BOARD OF APPEALS, CITY & COUNTY OF SAN FRANCISCO

Appeal No. **26-056**

NOTICE OF APPEAL

RE: Appellants' Brief in Appeal No. 26-056 for 280-282 Roosevelt Way

COVER & PROJECT INFO
PERMIT SET

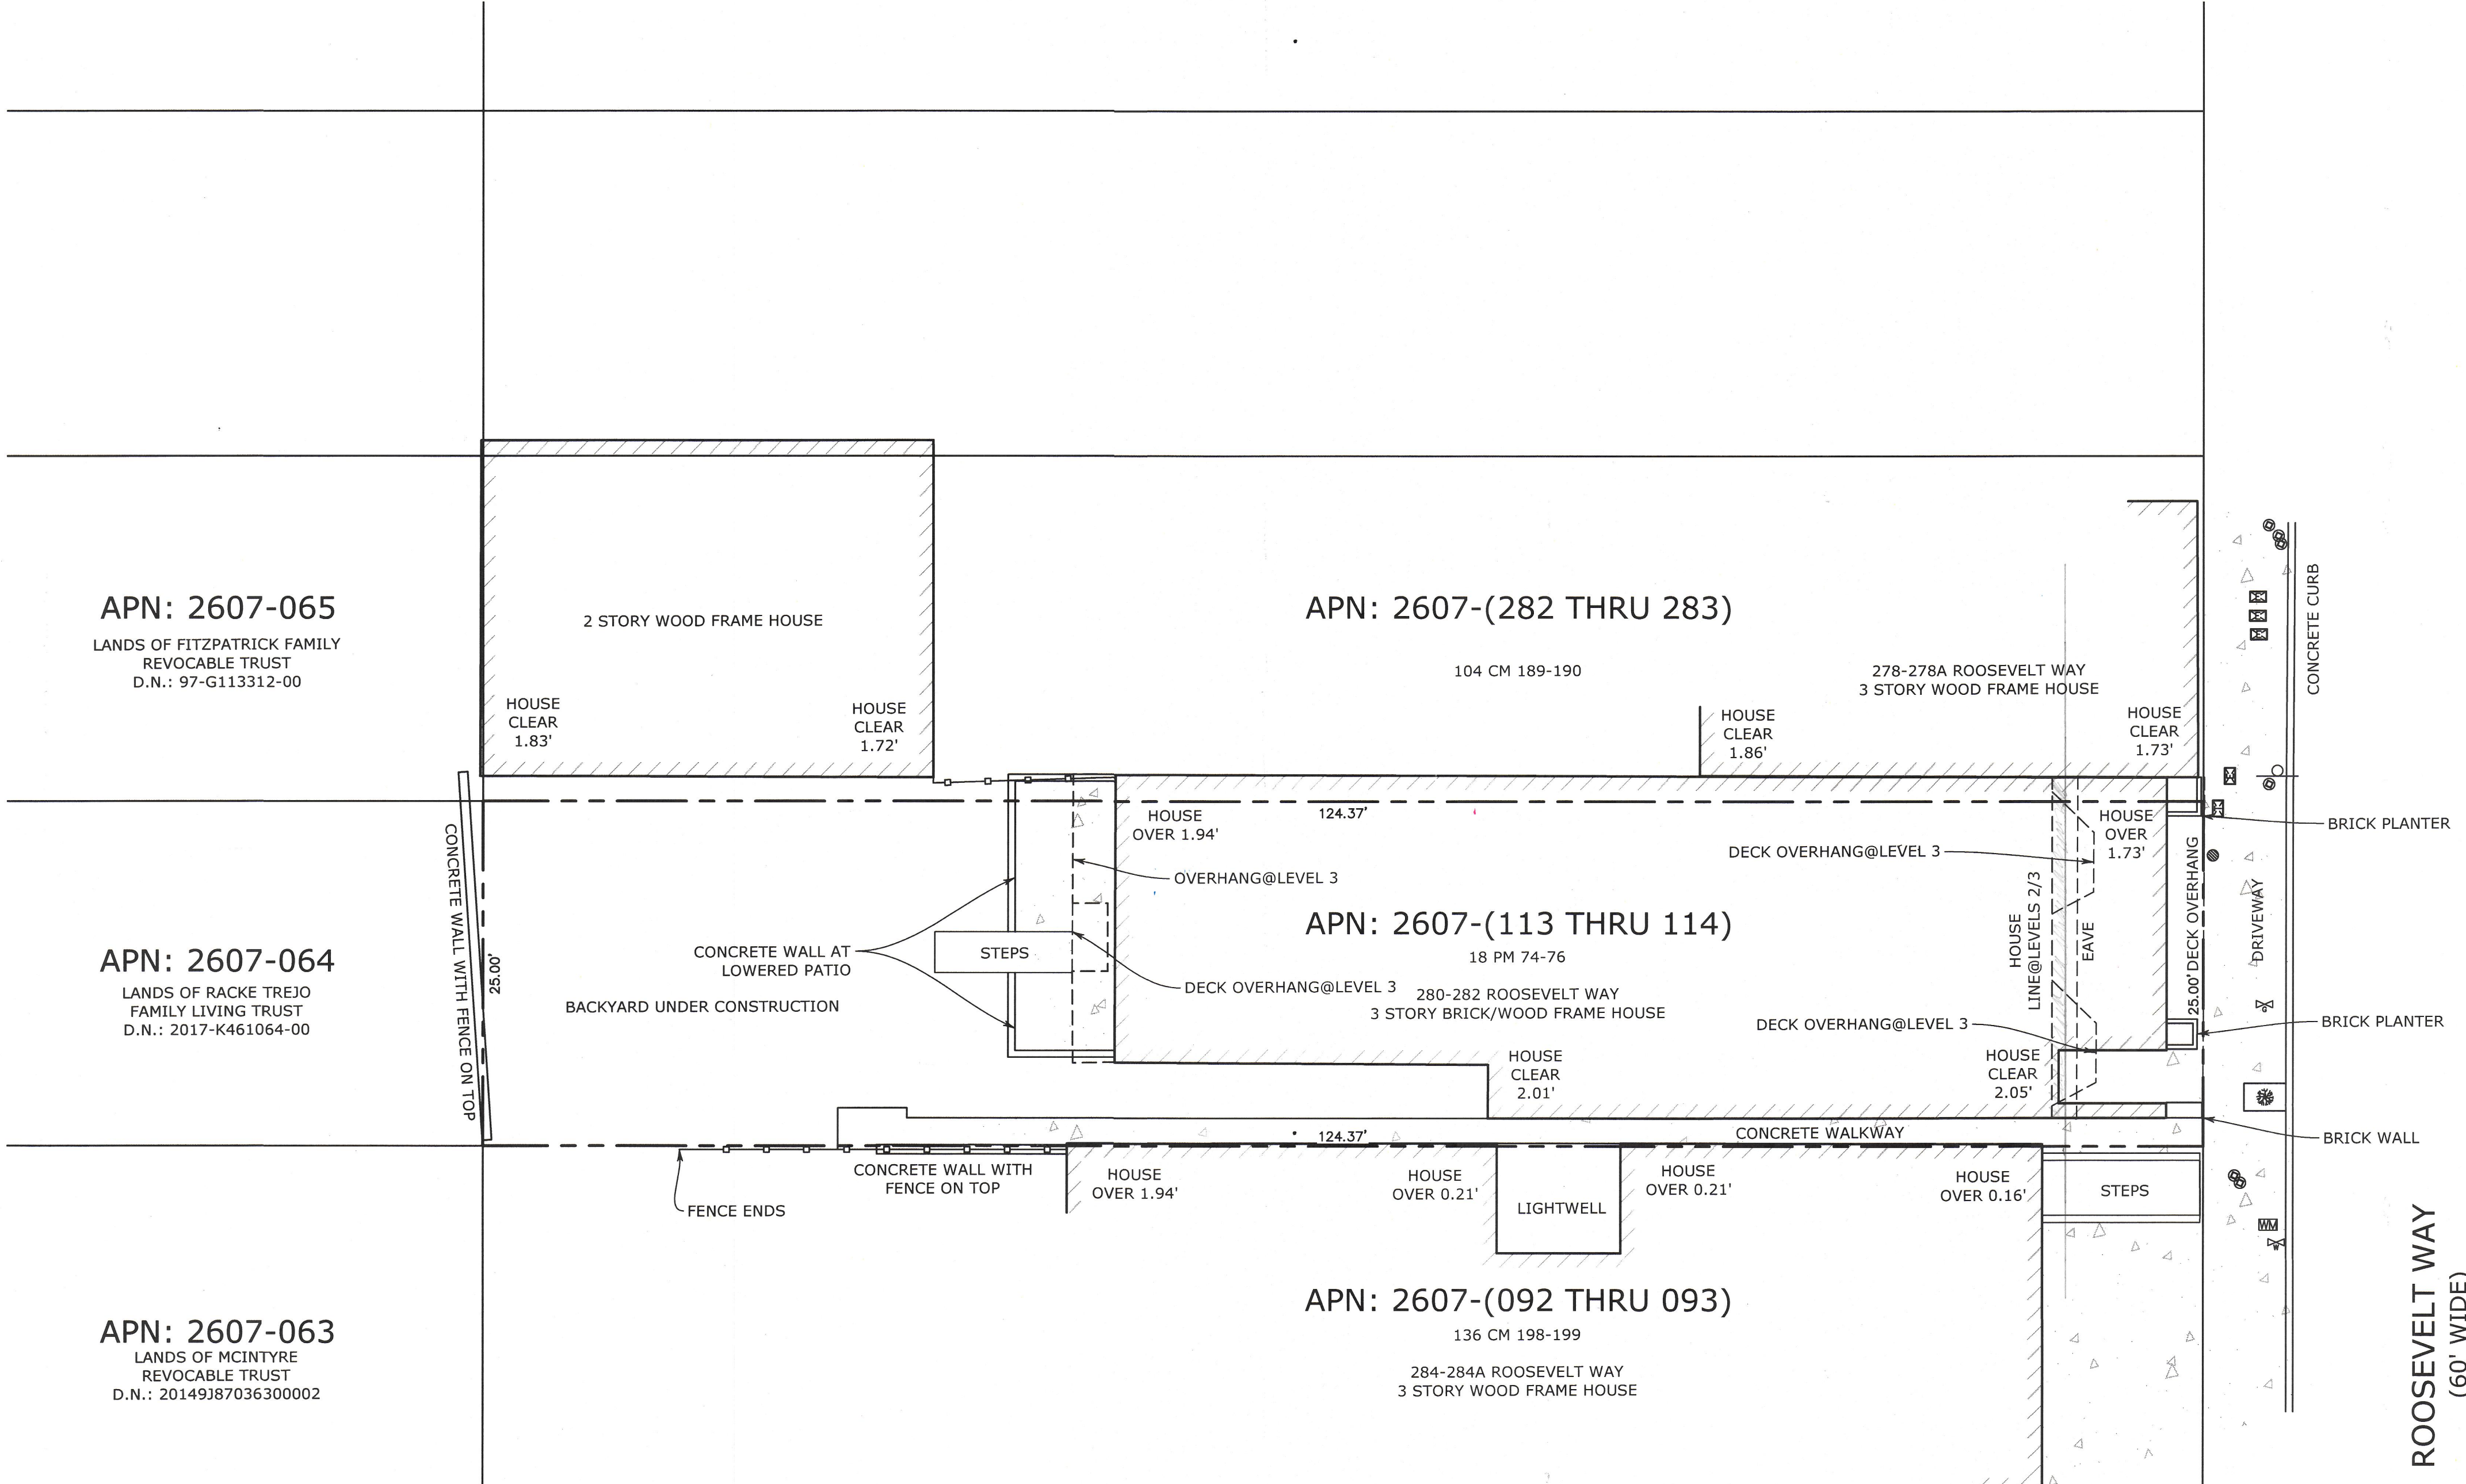
1. Under "BUILDING PROGRAM" on the Cover Sheet of the approved plans Item # 3 incorrectly states: "STAIR TO ROOF: NONE REQUIRED" and Item #4 incorrectly states: "EGRESS STAIRS: NONE REQUIRED". These notes are incorrect, as a stairway to the occupied roof is required and a means of egress stair from the roof is required.
2. With regards to compliance with applicable Building Codes, the proposed occupied roof deck complies with the California and San Francisco buildings codes, regardless of the erroneous notations noted in Item 1 above.

Based on the above analysis of the permit under appeal, DBI believes the proposed occupiable roof deck meets all requirements of the California and San Francisco Building Codes, and the approval of the occupiable roof deck was not in error. With that said, DBI will defer to the Board to either deny or uphold the appeal based on the issues the appellant raises with regards to privacy and setback requirements. If the appeal is upheld, and the Board requires the deck to be setback to meet the appellants' privacy concerns under a Special Conditions Permit, DBI would request the Architect correct the erroneous notations on the Cover Sheet of the plans regarding "Stairs to the Roof and Egress Stairs" not being required. If the Board denies the appeal but requires a Special Conditions Permit based on the outcome of Appeal No. 26-053, DBI would again request the Architect revise the erroneous notations on the cover sheet regarding the stairs, in the Special Conditions Permit Plans.

1 SITE PLAN - PROPOSED
A1.1 Scale: 1/8" = 1'-0"

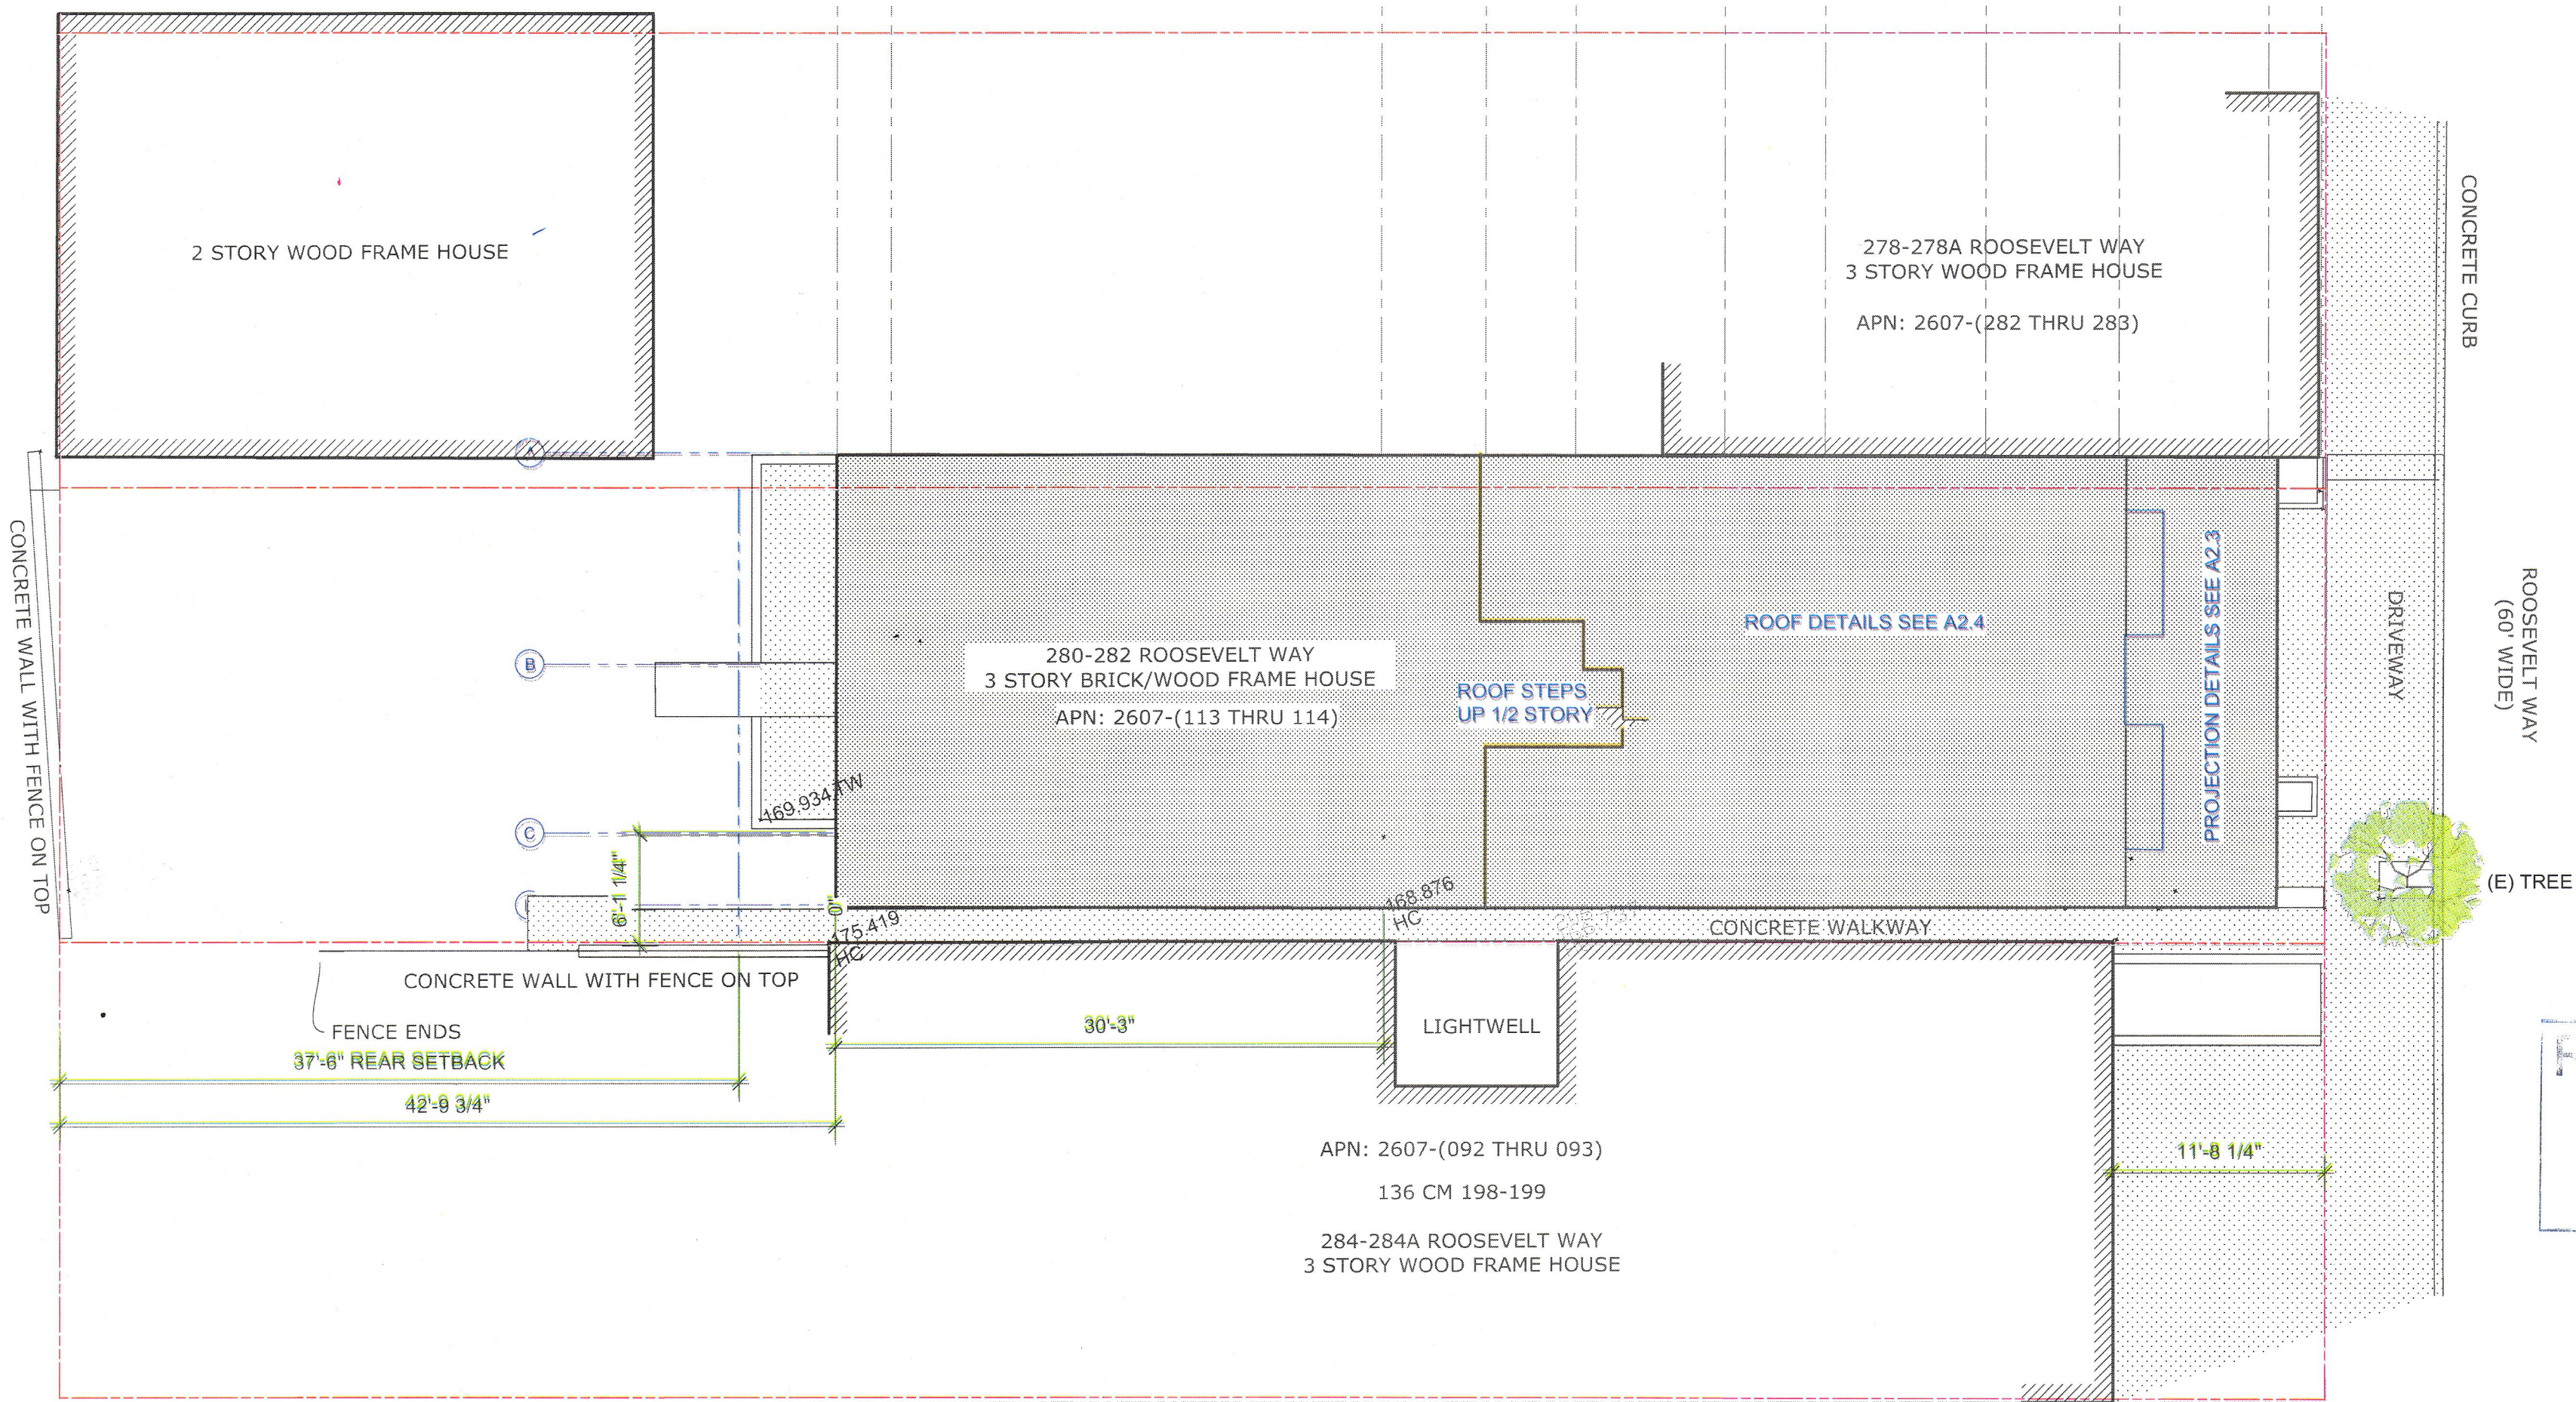
Our requested modification: Require a minimum five-foot setback on the side of the roof deck adjoining 284 Roosevelt Way. This focused condition would preserve outdoor space for the permit holder while moving deck activity away from the direct sightline into our primary bedroom.

The existing separation on our side is approximately 21.5 inches. By contrast, the roof deck is set back from the opposite adjoining property line, as shown in Exhibit D. The absence of a comparable setback on our side is especially consequential because this edge

The framework identifies the three-to-five-foot setback as a feature of over-the-counter review. Here, the approximately 21.5-inch separation falls well short of that feature. This apparent departure, together with the direct sightline into our primary bedroom, warranted closer review of the site-specific privacy impact rather than routine over-the-counter approval. Although the Guidelines are not a categorical setback requirement in every case, they directly identify the privacy concern and the measure Planning encourages to address it. Relevant excerpts appear in Exhibit E.

Requested action: We respectfully ask the Board to modify Alteration Permit No. 2026/08/17/6686 to require a minimum five-foot setback between the usable roof-deck area and the shared property line with 284 Roosevelt Way. The condition should be reflected in revised approved plans and implemented before use or occupancy of the roof deck. This limited modification follows Planning's roof-deck guidance and directly addresses the bedroom sightline, the approximately 21.5-inch existing separation, and the unequal side setbacks documented in Exhibits A through D. We appreciate the Board's time and consideration.

The subject Permit is not fully compliant with the Planning Code and Residential Design Guidelines as approved. The Department respectfully requests that the Board grant the appeal and approve the permit in a manner that 1) adequately addresses the work proposed on the adjacent lot to the north, 2) authorizes an administrative modification per Planning Code Section 307(h)(1)(F) to allow the front balcony to remain as proposed, and 3) revises the roof deck to provide a 5-foot setback from the shared property line to the south.
